ADDENDUM 1_April 11, 2024

RE: Addendum No. **One (1)** to the Bidding Documents for:
York Maintenance Facility Vehicle Storage Garage, Mile 6.8, York, ME

YORK VEHICLE STORAGE GARAGE

ADDENDUM #1 4-11-24

CONTRACT 2024.09
YORK VEHICLE STORAGE GARAGE
SITE AND UTILITY PLAN

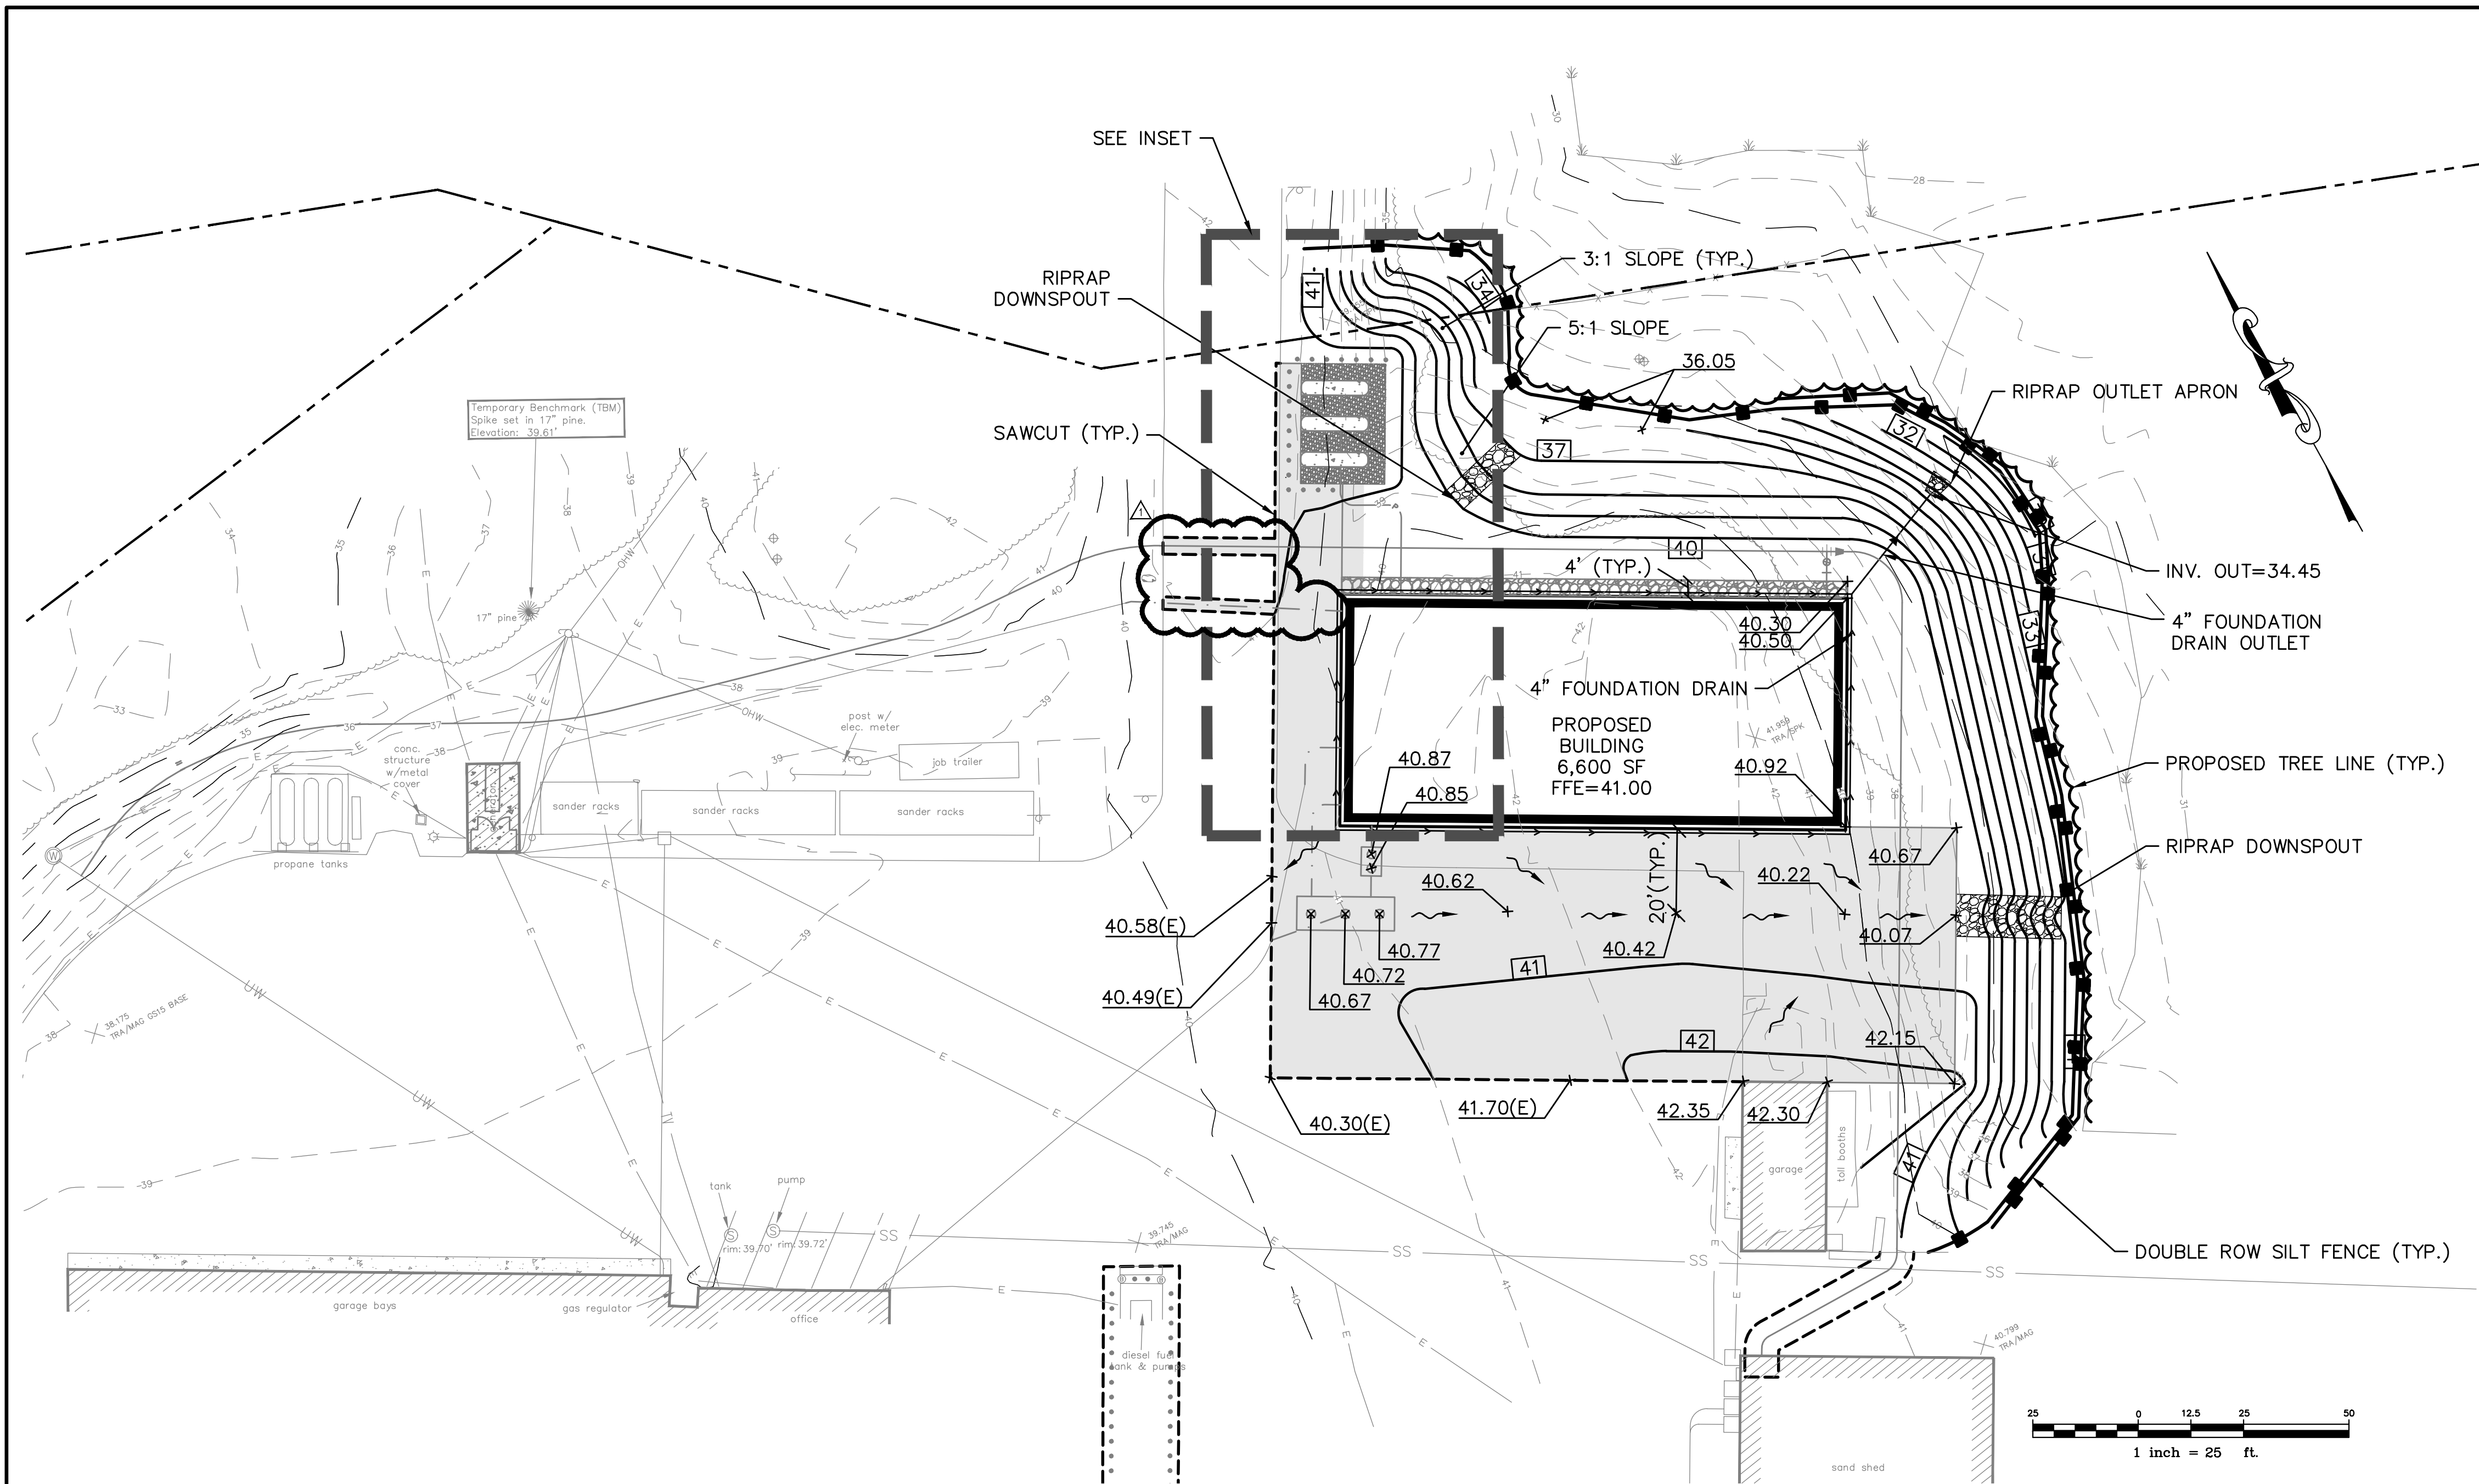
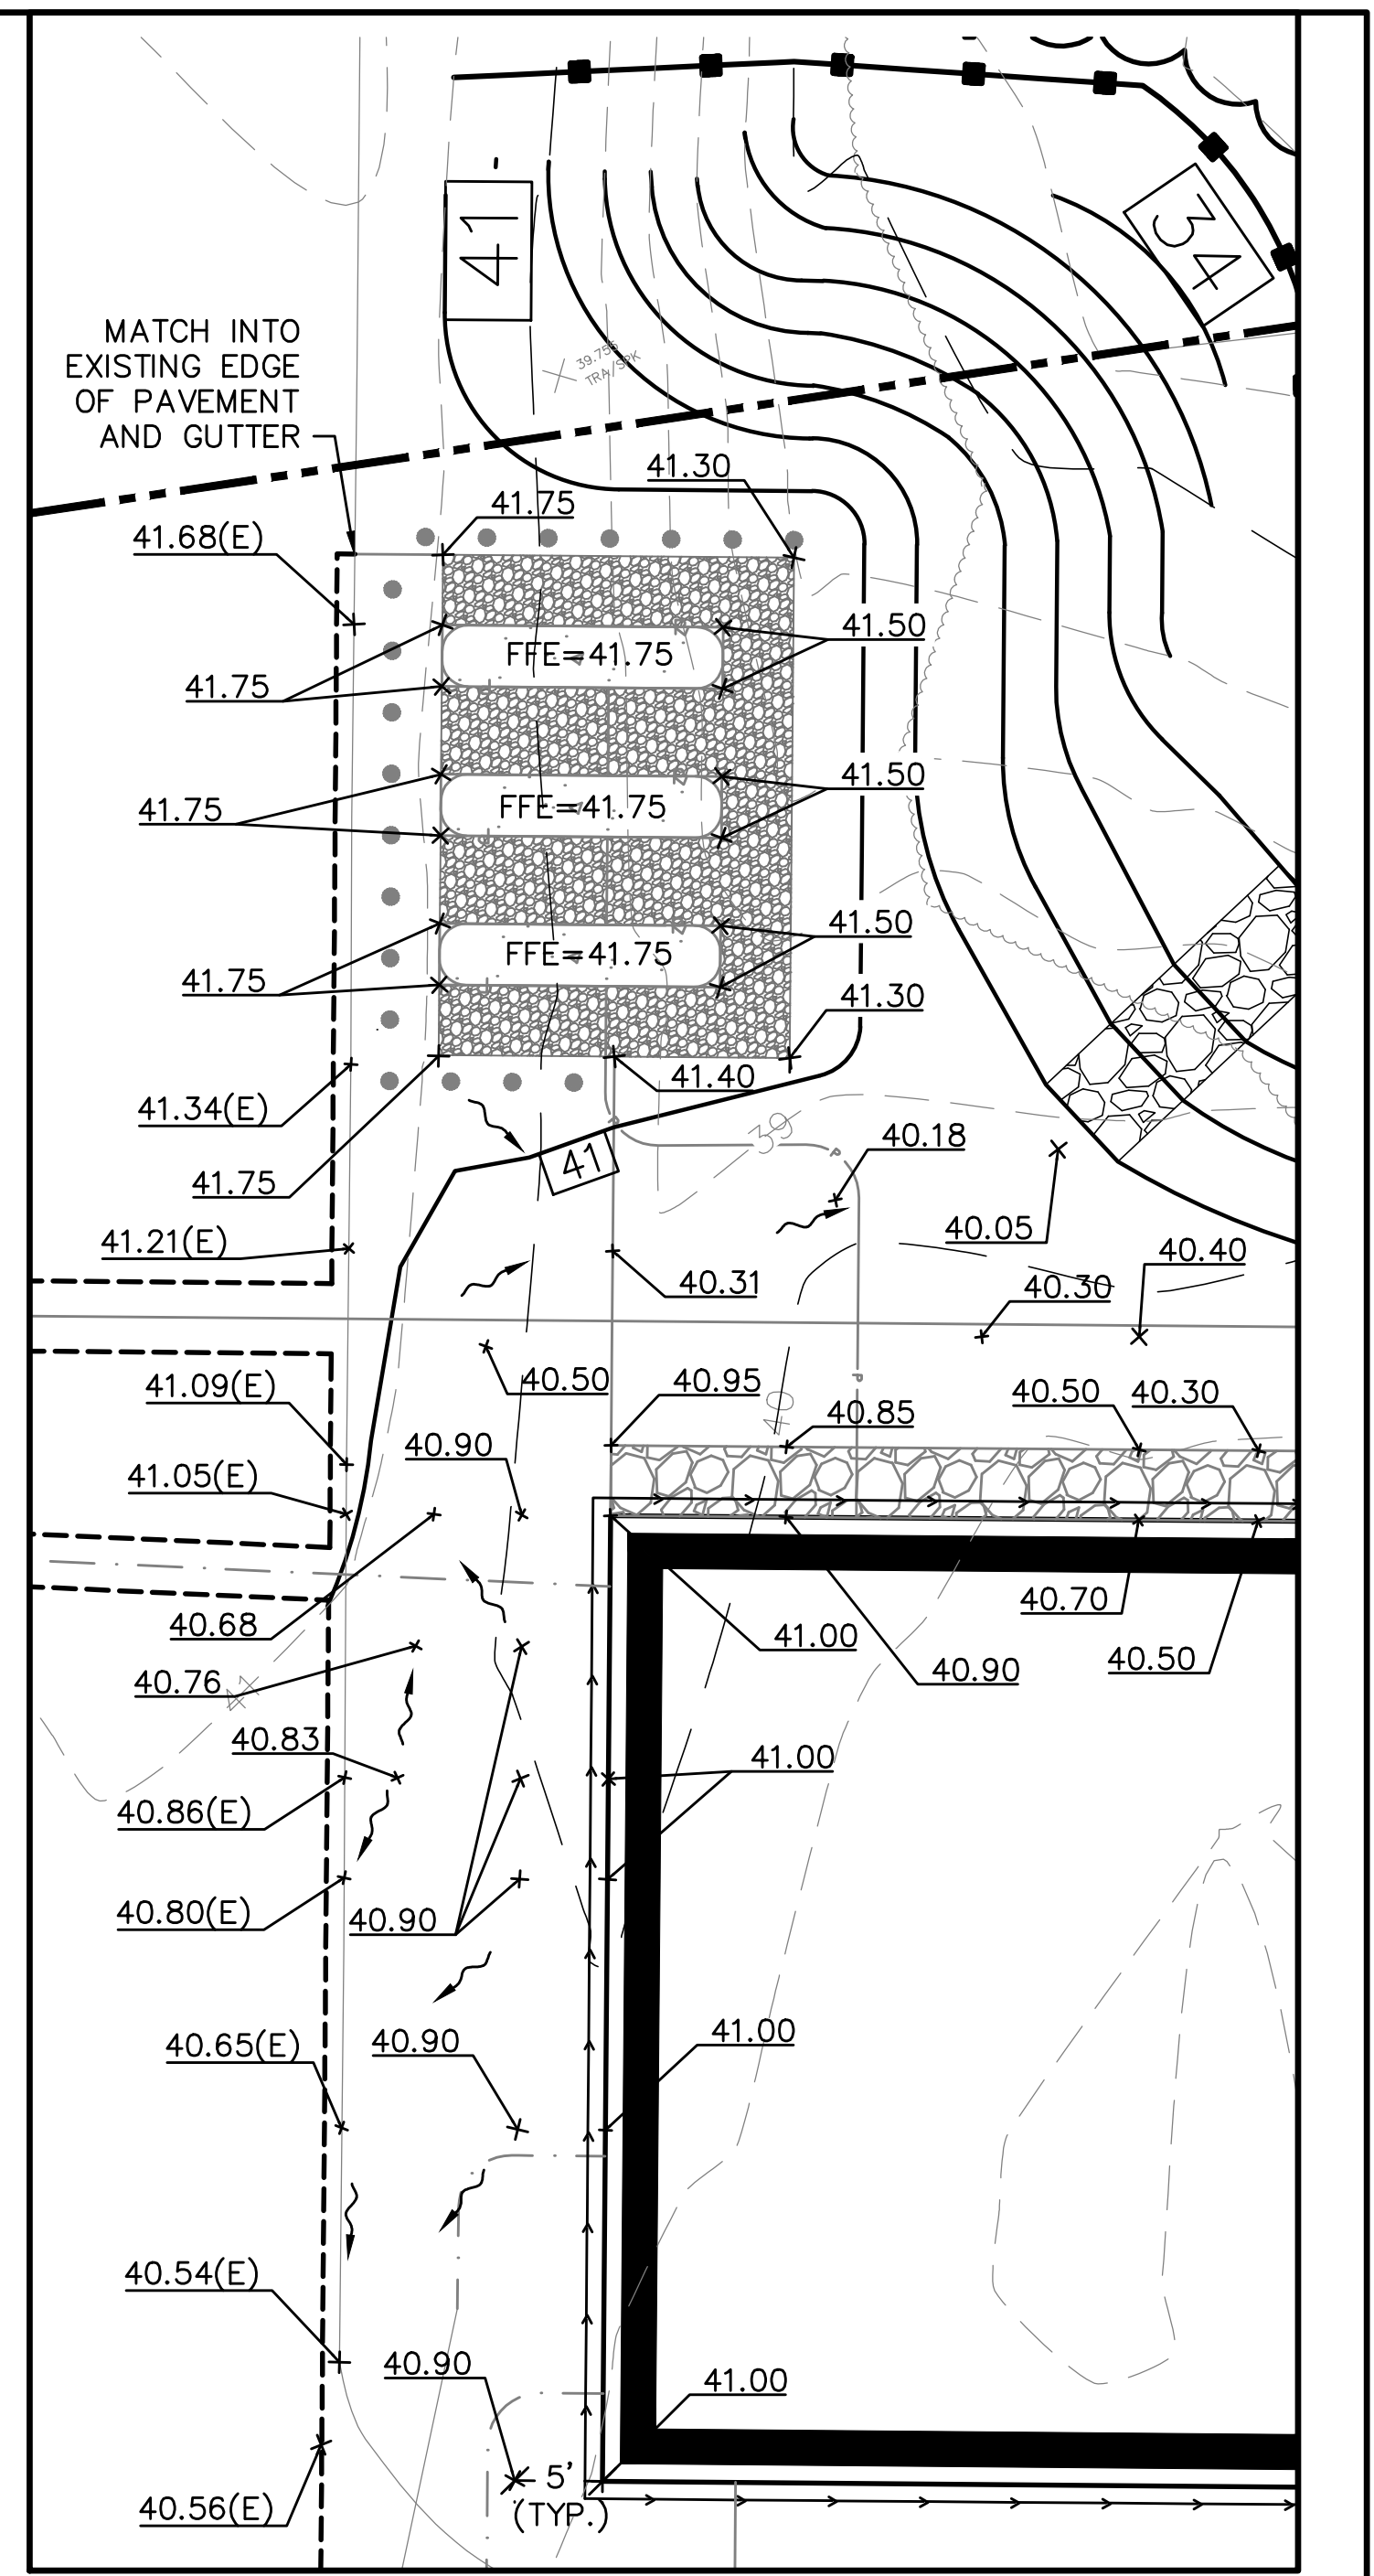
1. **Drawing A-7** The structural drawings are showing typical foundation wall to be 8” width. Detail 4/A-7 shows a 10” wall.
AEI Response: All foundation walls are 8" as shown on structural drawings.
2. **Drawing C-101 and C-401:** There appears to be a discrepancy between the propane tank dimensions indicated on the Site and Utility Plan C-101 & the Precast Propane Tank Pad detail on sheet C-401.
AEI Response: The detail on Sheet C401 has been revised so that the pad dimensions match those depicted on the Site Plan.
3. **Specification Section 033000:** Are the reinforcing bar supports in the slab required to be epoxy coated?
AEI Response: No, bolsters are not required to be epoxy coated.
4. **Specification Section 077200:** Specification includes a spec for Roof Curbs. I don’t see where this would pertain.
AEI Response: There are no roof curbs on this project.

A1 ELECTRICAL SCHEDULES **A7 ELECTRICAL GROUNDING DETAIL**

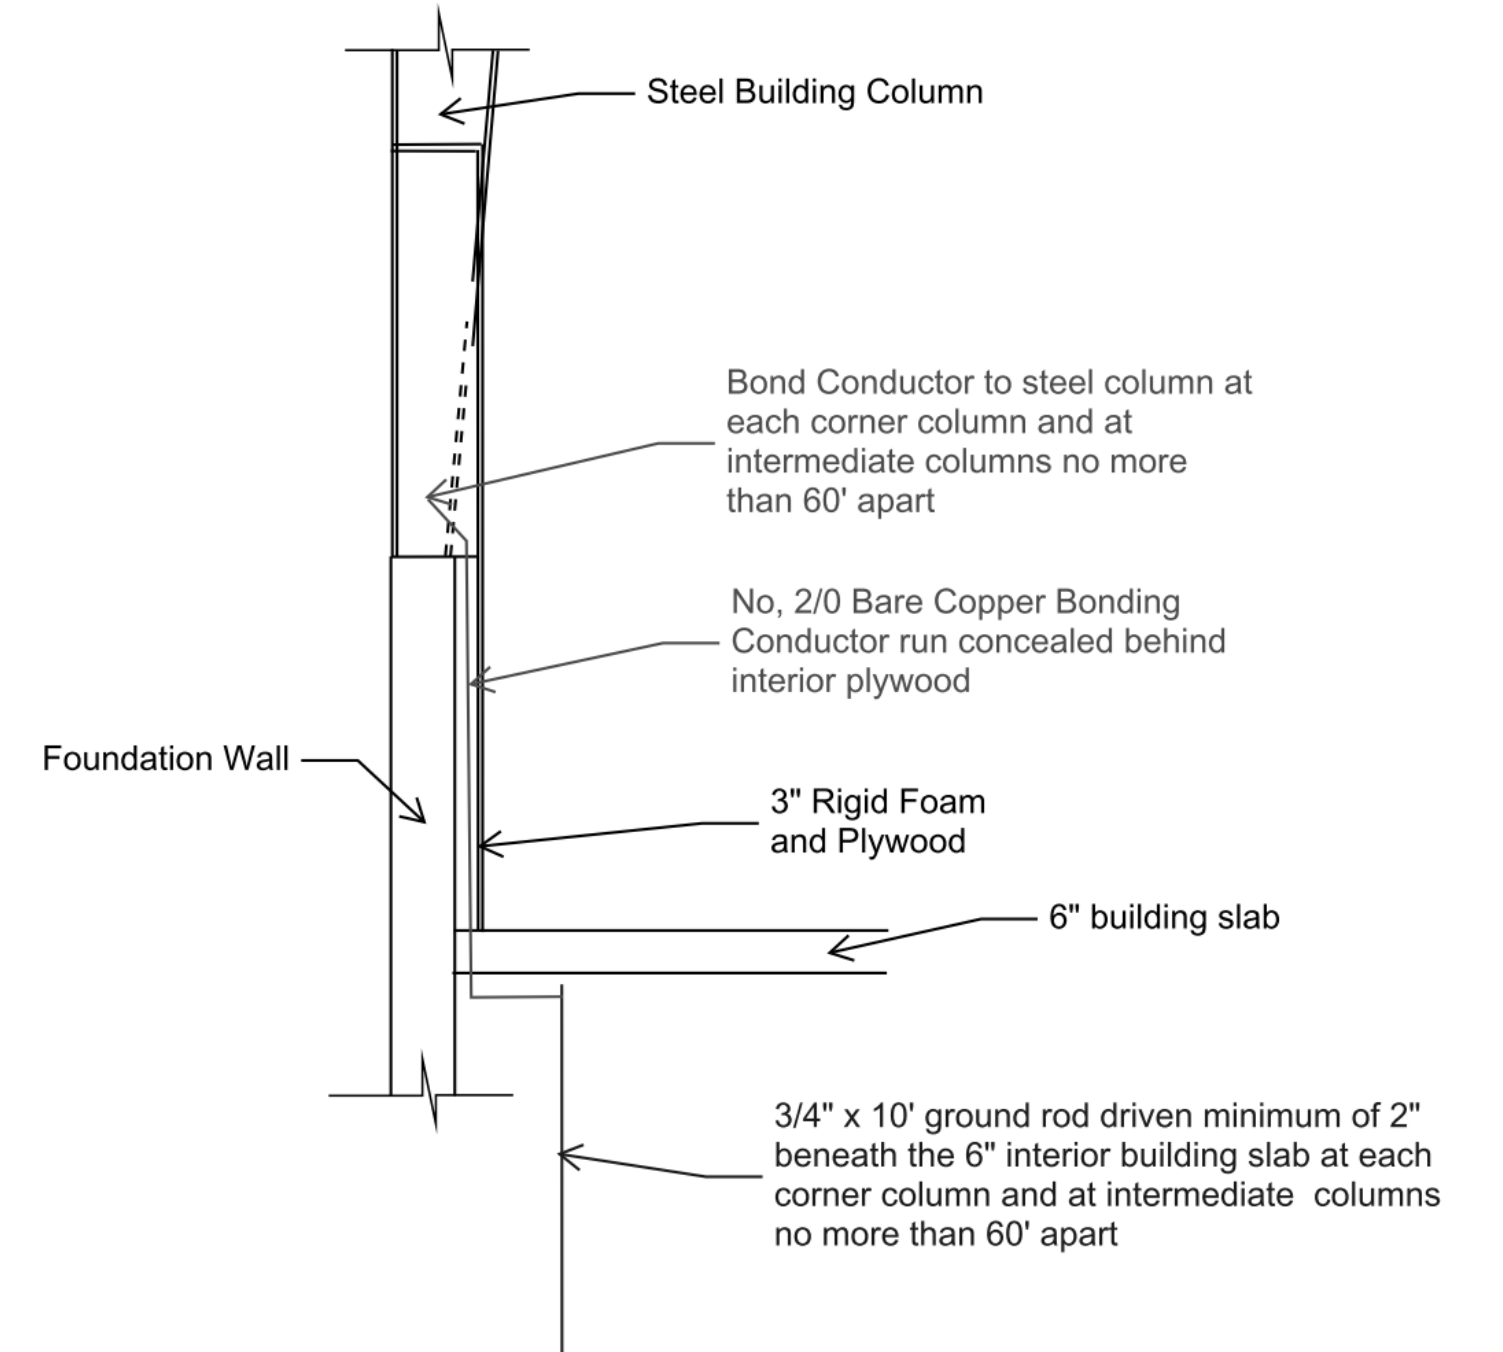
Grounding at metal building steel column per special provision 260526.3.5G
